PREVOST

**WARRANTY
BULLETIN**

WB13-63A

DATE :	OCTOBER 2013	SECTION :	06 - Electrical
EXPIRATION:	OCTOBER 2015		
SUBJECT :	70 AMP CIRCUIT BREAKER INSPECTION AND REPLACEMENT

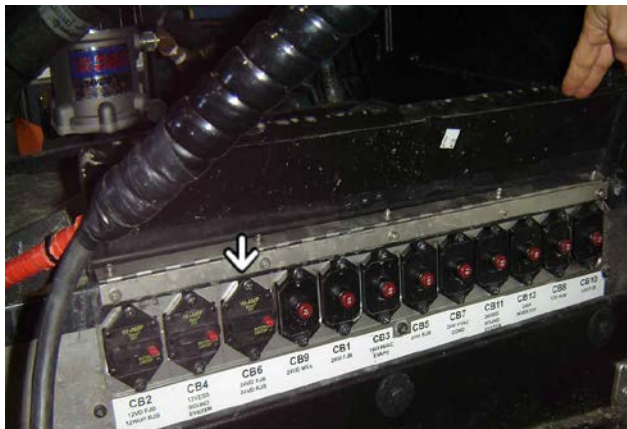
4. H3-45 VIP shells:

Locate CB4 and CB6
